1.0 Introduction

G-IV s/n 1225, N450KK is currently operated by La Venezolana de Seguros y Vida CA.

G-IV S/N 1225 Structural Evaluation-Over Pressurization Event

Fig. 2-1

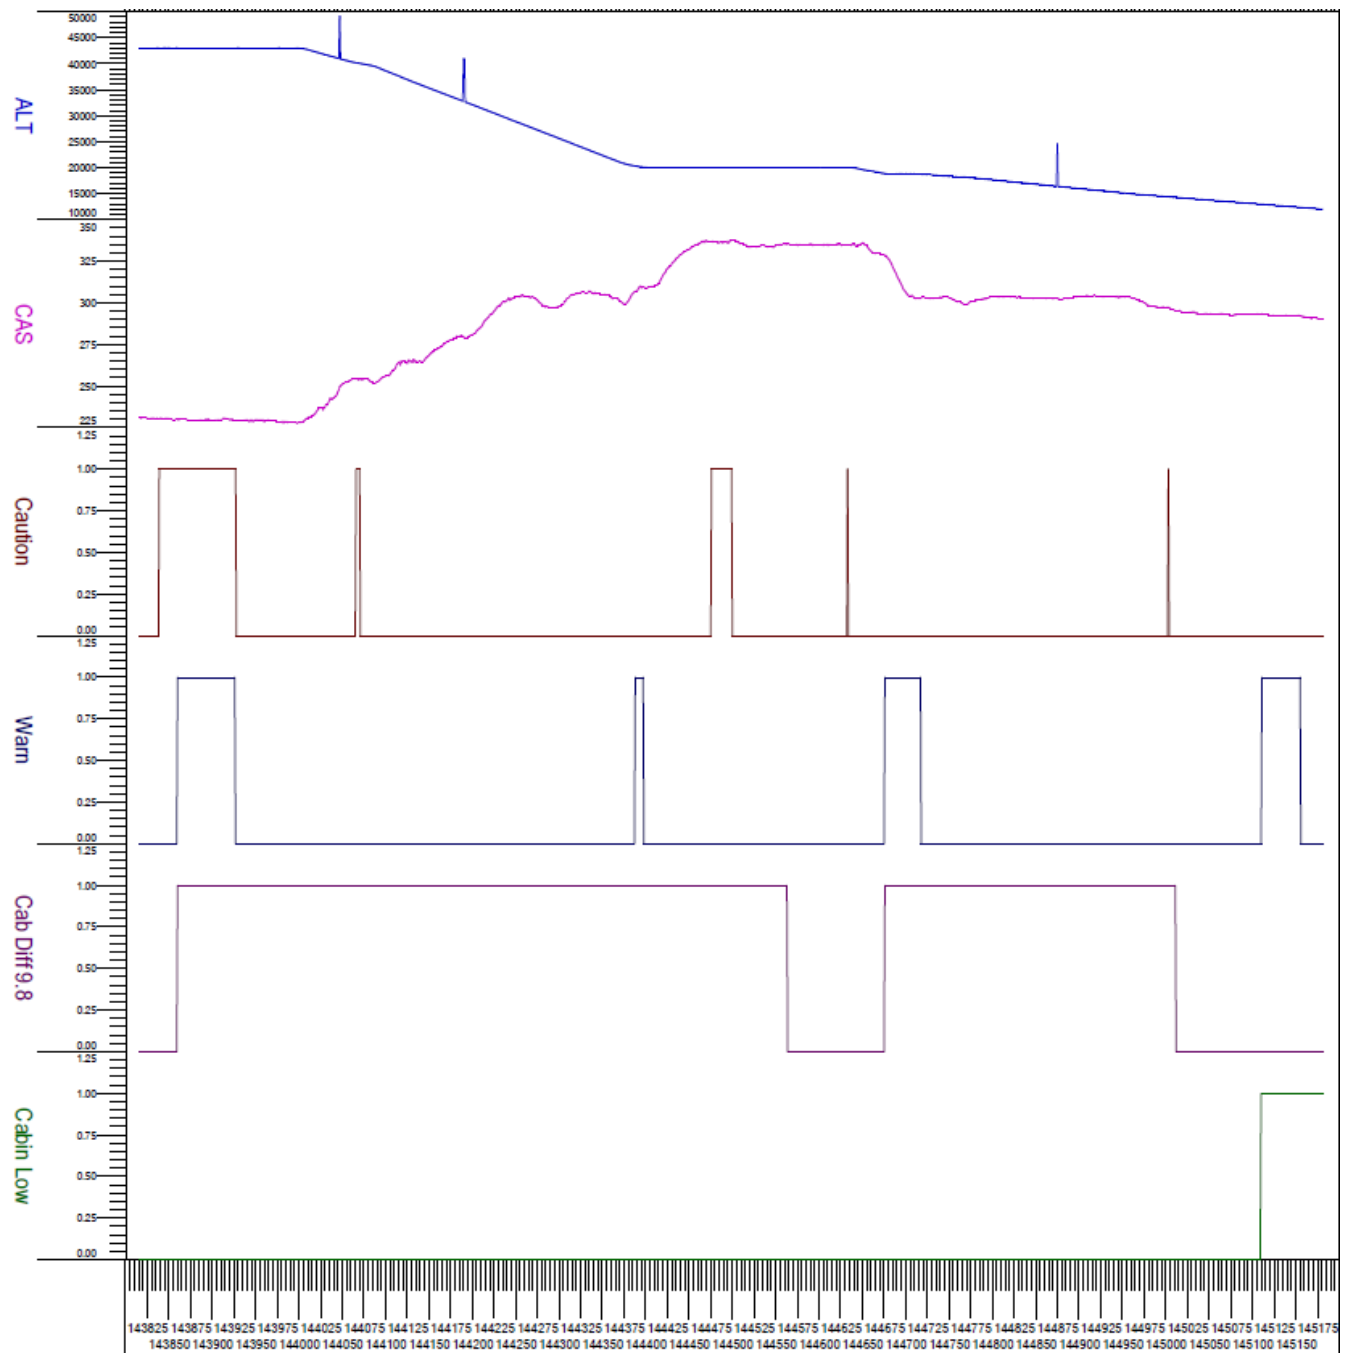
- B. Comments on FDR download:
- i. Lateral acceleration is not recording properly
 - ii. Reviewed the FDR and did not see any exceedances with vertical G's or with pitch and roll rate. Maximum vertical G's was less than +/- 0.5 G's. Could not find any indication that the aircraft had high lateral or vertical G's or any high (roll or pitch) rate of change.

- iii. No FDR data to support if the safety valve operated correctly.
 - iv. The FDR does not record Cabin Pressure/Altitude.
 - v. The FDR shows that the first over pressure 9.8 message was on for 704 seconds and 336 seconds the second and final time with a 112 second gap.

- vi. 98 seconds after the over pressure 9.8 message goes out the second time, the Cabin pressure Low message illuminates.
 - vii. Bleed air pressure was normal and never selected off (based upon engine performance and aircraft altitude).

- viii. The Crew did not follow the AFM recommend steps for an Amber "Cabin DFRN 9.6" or a Red "Cabin DFRN 9.8" CAS message.
 - ix. The over pressurization message does not appear to be an indication failure.

- x. Recommend a Chapter 5 "Pressure Differential Exceedance – Inspection". It is unknown if the safety valve operated correctly.

Fig. 2-2
Aural Warning Speaker with covering removed.

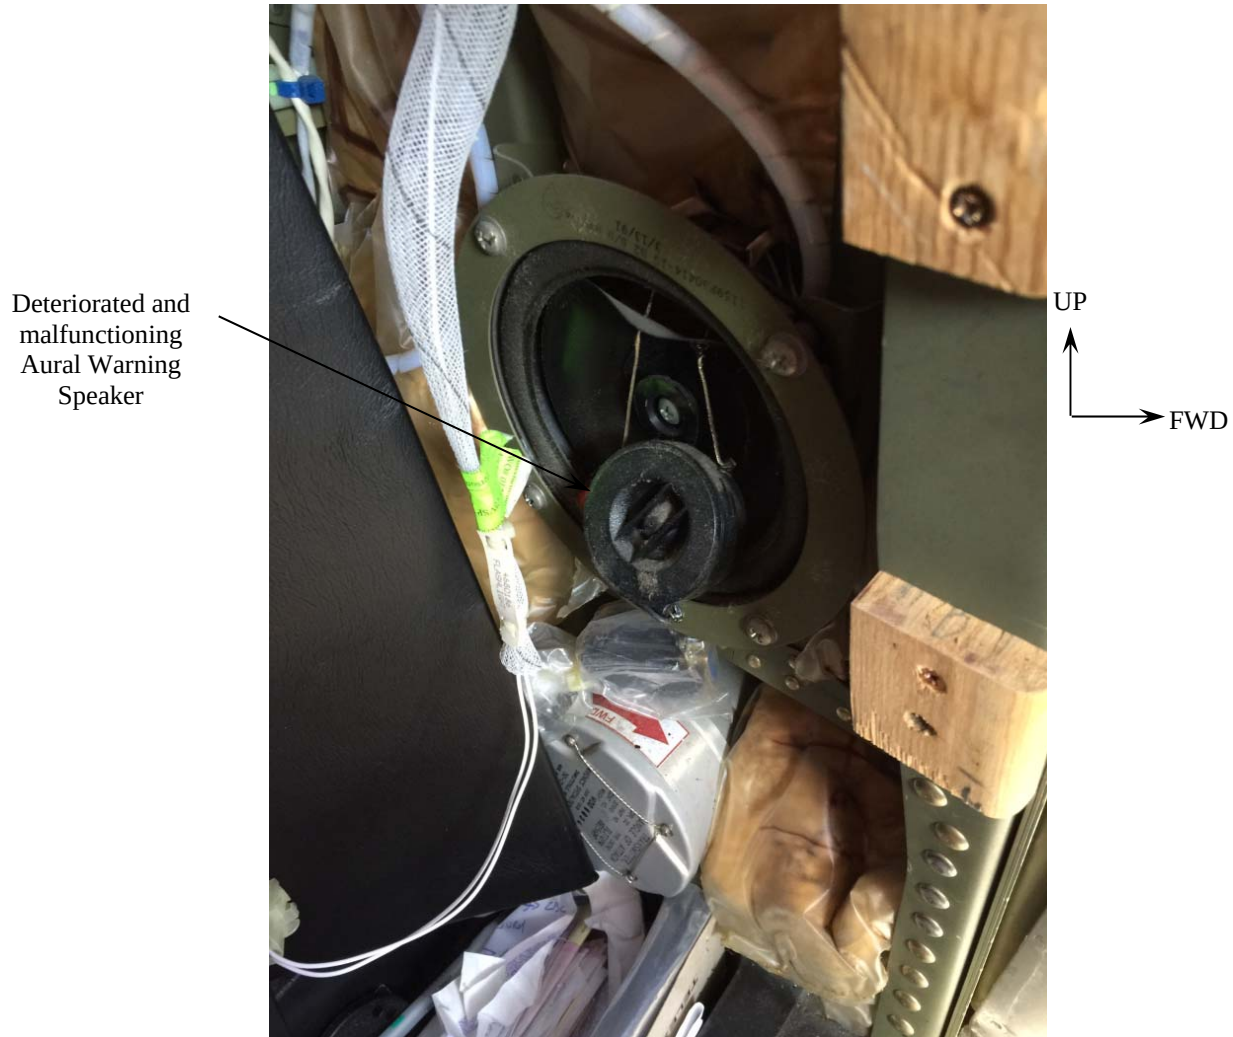
- C. An initial inspection of the aircraft by RJM personnel provided the following information:
- i. The Aural Warning Speaker showed evidence of deterioration.
 - ii. The Aural Warning Speaker volume was not functioning properly.

- iii. Trouble shoot the Aural Warning Speaker system to determine the cause of the volume problem.
 - a. Replace parts and adjust the system as required to obtain proper function..
 - iv. Clean and remove the Foreign Object Debris (FOD) from the Outflow Valve Safety Port system in accordance with Chapter 21-02-05 of the G-IV MM and/or the applicable CMP Card.
 - a. After cleaning the Outflow Valve Safety Port system, perform a functional test of the system in accordance with Chapter 21-02-05 of the G-IV MM and/or the applicable CMP Card.
- Note: RJM Personnel initially tried to clear the Safety Port by using the air pressure procedure but were unsuccessful. The Safety Port was ultimately cleaned out by using flexible wire prior to GAC Representatives arrival. While on-site, it was observed that the Safety Port was again plugged with “Mud Dobber” debris

Fig. 3-1

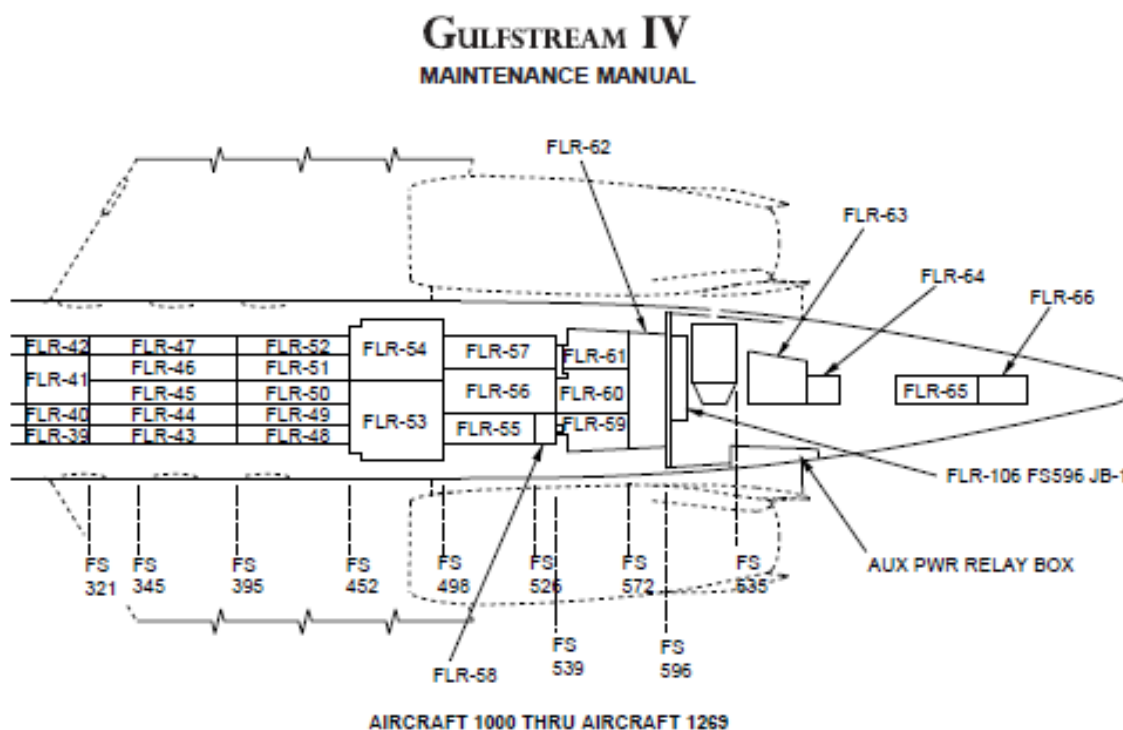
- i. Floor panels FLR-44, FLR-46, FLR-50 and FLR-51 (Ref. Fig 3-1) were unfastened and removed from the aircraft to gain access to accomplish an under floor inspection of the fuselage floor structure.
- ii. Floor panel FLR-44 (1159BH21001-407) exhibited evidence of crushed core and insert damage around the fasteners attaching the panel to FS 379 Intercoastal Installation.
- iii. Floor panels FLR-46, FLR-50 and FLR-510 did not visually exhibit any evidence of crushed core or pulled/working inserts.
- iv. A visual evaluation of the floor boards between FS 345 thru 452 indicated mismatches and distortion at the fastener rows attaching the floor boards to the floor beams at LBL 6.0, LBL 18 and LBL 30.5. The floorboards located between RBL 6 to RBL 30.5 appeared to be flat.
- v. See Section 4.0 for the findings related to the floor beams and underlying structure.

- i. Replace the 1159BH21001-407 Floorboard and associated hardware with new parts in accordance with Chapter 53-30-00 of the G-IV MM and/or applicable CMP Cards.
- ii. Visually and NDT Inspect floor panels FLR-43, FLR-45, FLR-46, FLR-47, FLR-48, FLR-49, FLR-50, FLR-51, FLR-52, FLR-53, FLR-54 (ref. Fig. 3-1) for 10isbanding, crushed core, elongated holes, loose/working inserts and any other discrepant condition(s).
- iii. Visually inspect the adjacent and underlying structure as instructed in Sections 4, 5 and 6.
- iv. Document any discrepant conditions identified and submit to GAC Technical operations for further evaluation.
- v. If no discrepancies are found on a panel, it may be reused and installed in accordance with Chapter 53-30-00 of the G-IV MM and/or applicable CMP Cards.

Fig. 4-2

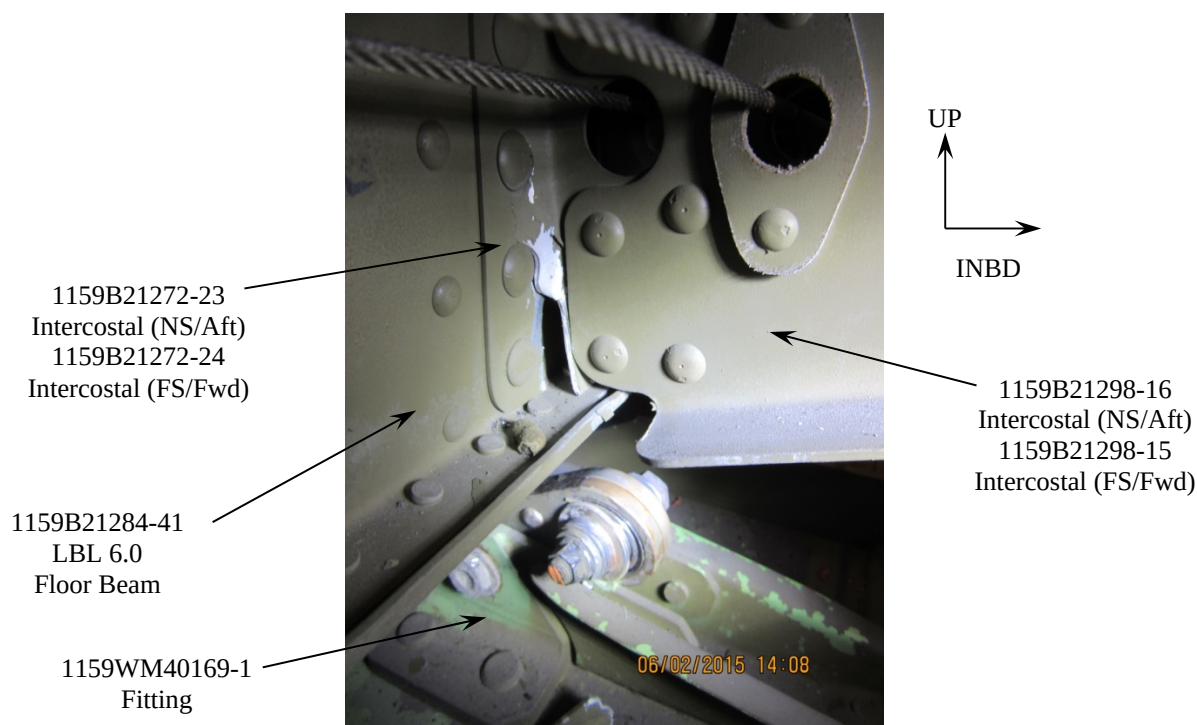
- i. The 1159B21298-11 Intercostal between LBL 30.5 and LBL 18.0 was deformed and bent.
- ii. The 1159B21298-15/-16 Intercostals between LBL 6.0 and RBl 6.0 was deformed and bent. The 1159B21272-23/-24 brackets attaching the 1159B21298-15/-16 Intercostals to the LBL 6.0 Floor Beam were cracked.
- iii. Due to the interior and floor board installations, the remaining areas of the 1159B2198-3 Intercostal Instl were inaccessible to be viewed. A complete inspection will be required to determine the full extent of the damage to the 1159B21298-3 Intercostal Instl..
- iv. Numerous other small parts and components may be damaged but not identified in this report. They will need to be identified and documented during the detailed inspection and evaluation.

- i. Do a complete visual inspection of the 1159B21298-3 Intercostal Instl
 - a. Identify and replace any discrepant parts with new parts as required.
Note: Section 5.0 of this report identifies the replacement of the Floor Beam(s) and associated components and should be worked in conjunction with the requirements of this section.
 - b. Document and submit to GAC Technical Operations any structural damage identified with a full description and digital photos for evaluation.

Fig. 5-4

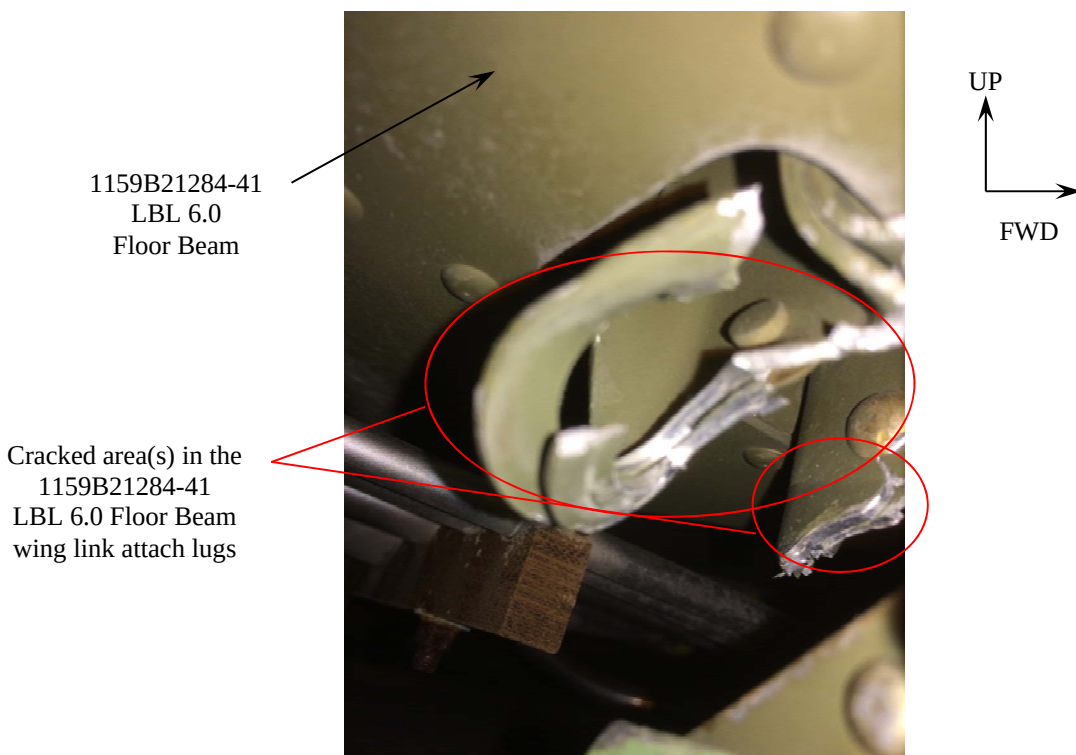
- a. The 1159B21284-41 Beam Installation was cracked and distorted at the following locations:
 - (a) FS 360 - (Inboard and Outboard Sides) (Fig. 5-1).
 - (b) FS 388 - (Outboard Side) (Fig. 5-2).
 - (c) FS 391.5 - (Inboard Side) (Fig. 5-2).
 - (d) FS 452.50 - The attachment joint had indications of diagonal buckling on the aft 6" of the web on the inboard and outboard side of the beam (Fig. 5-3).
 - (e) The FS 379.00 Wing Link Attach Fittings were fractured (Fig. 5-4 to 5-6).

- iii. Repair/Resolution:
 - a. Remove and replace the 1159B21284-41 Floor Beam to the requirements of the 1159B20005-7 Structure Assy and 1159B20005-5 Structure Instl.
 - b. Document and submit to GAC Technical Operations any structural damage identified with a full description and digital photos for evaluation

Fig. 5-7

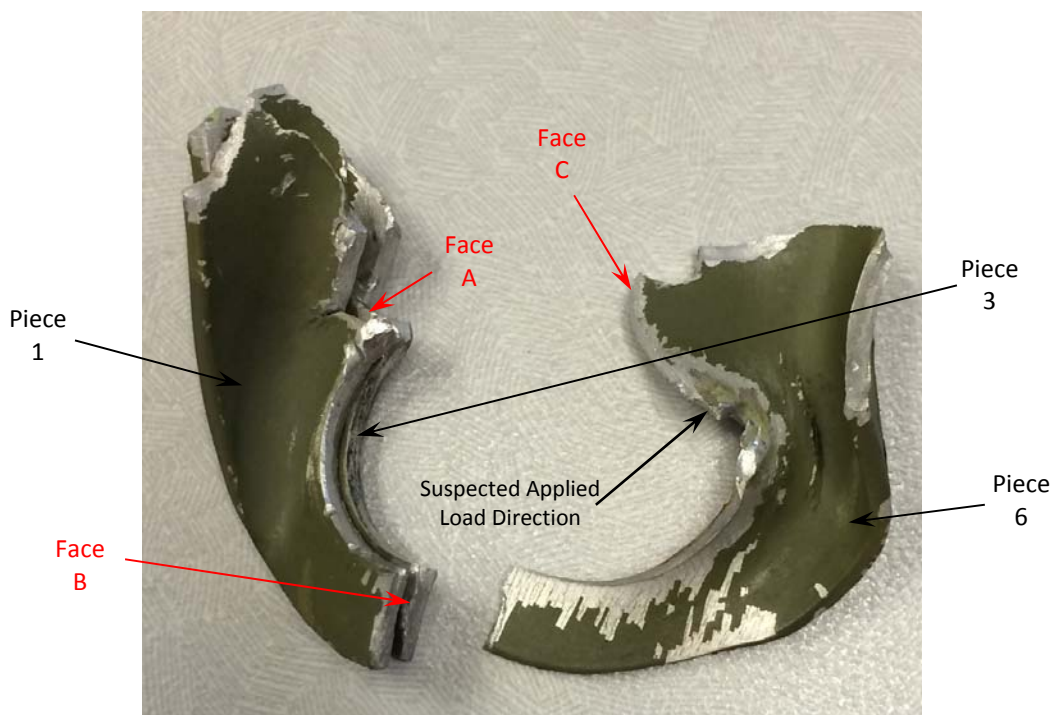
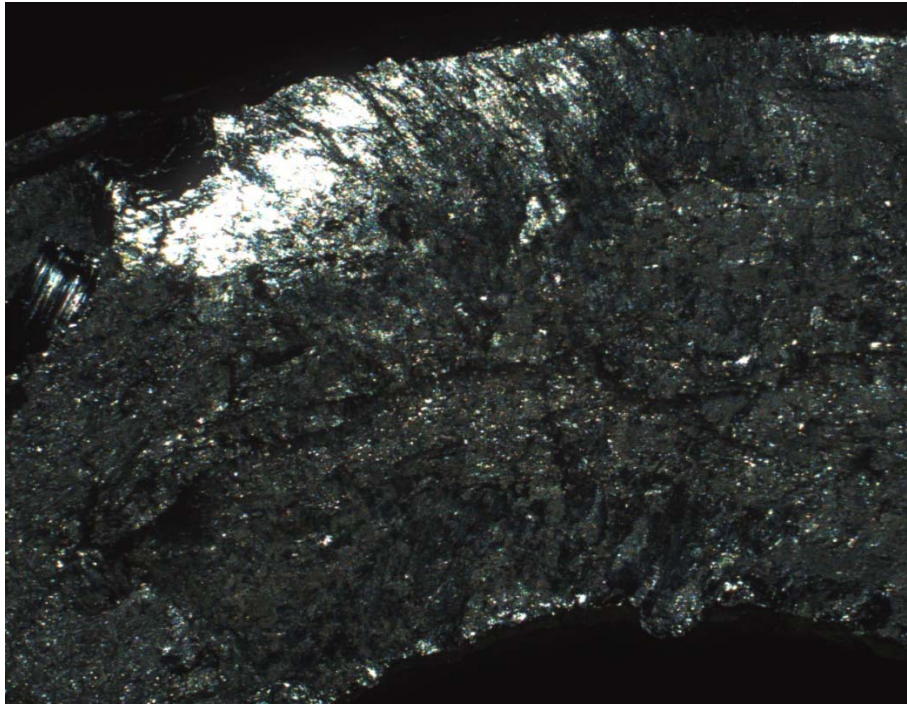
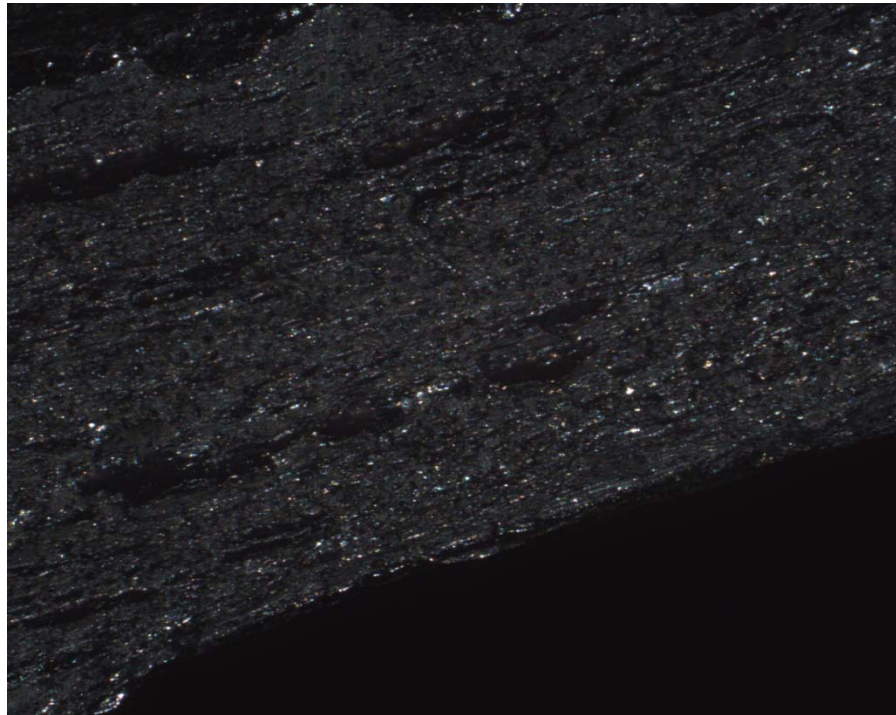
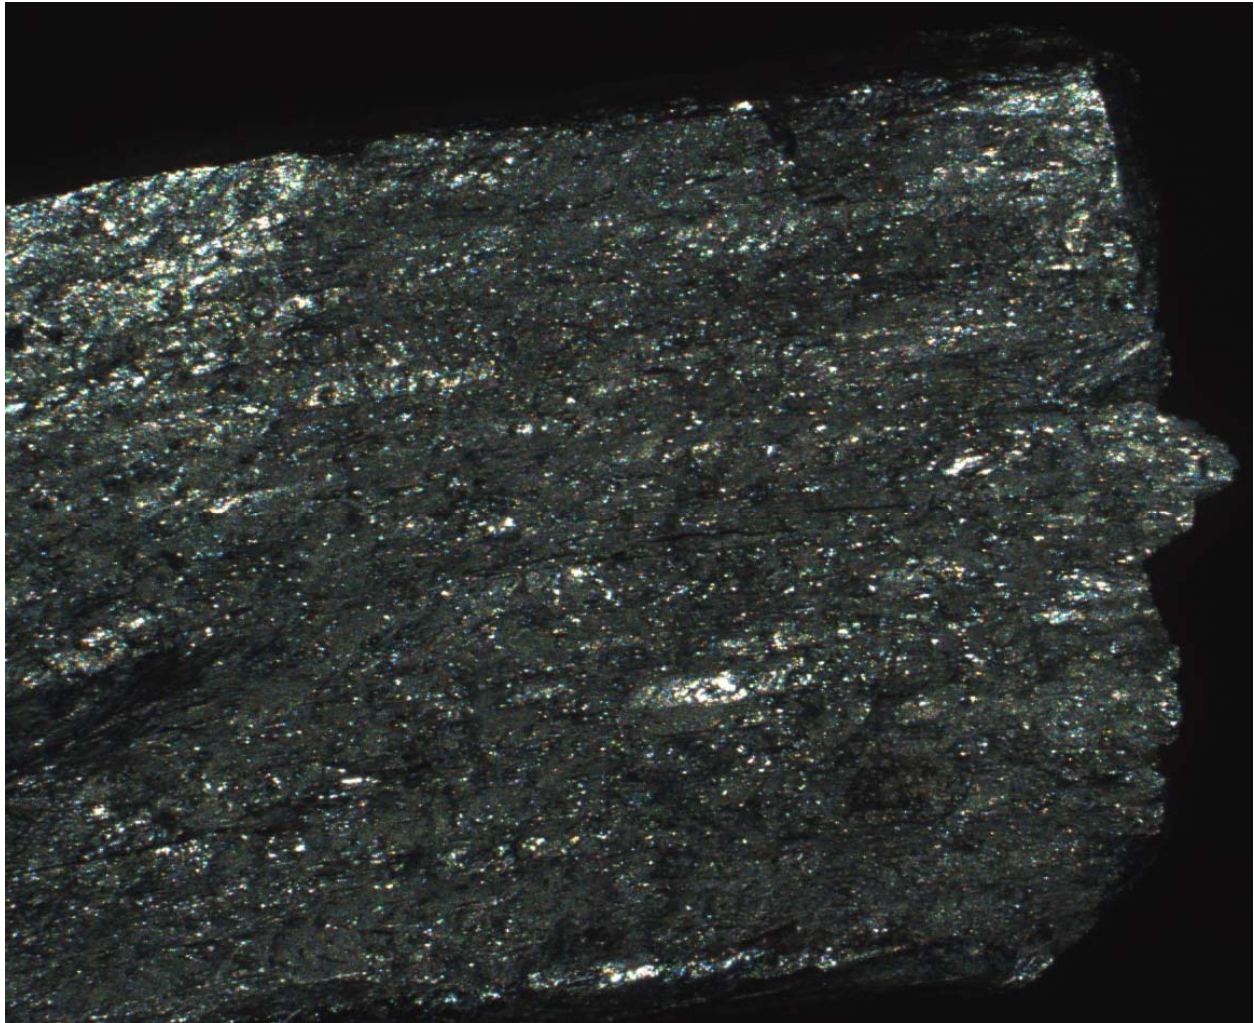
e. An initial evaluation of the fractured surface(s) of parts 1, 3 and 6 under a 50X Power microscope indicated a “Ductile Overload Failure” of the surface.

Face A-Crack Opened Mechanically To Reveal Crack Face
Tearing from Elongation. Failure Mode: Ductile Overload

Face B-Net Section Tension Failure
Failure Mode: Ductile Overload

Face C-Failure area adjacent to applied load
Failure Mode: Ductile Overload
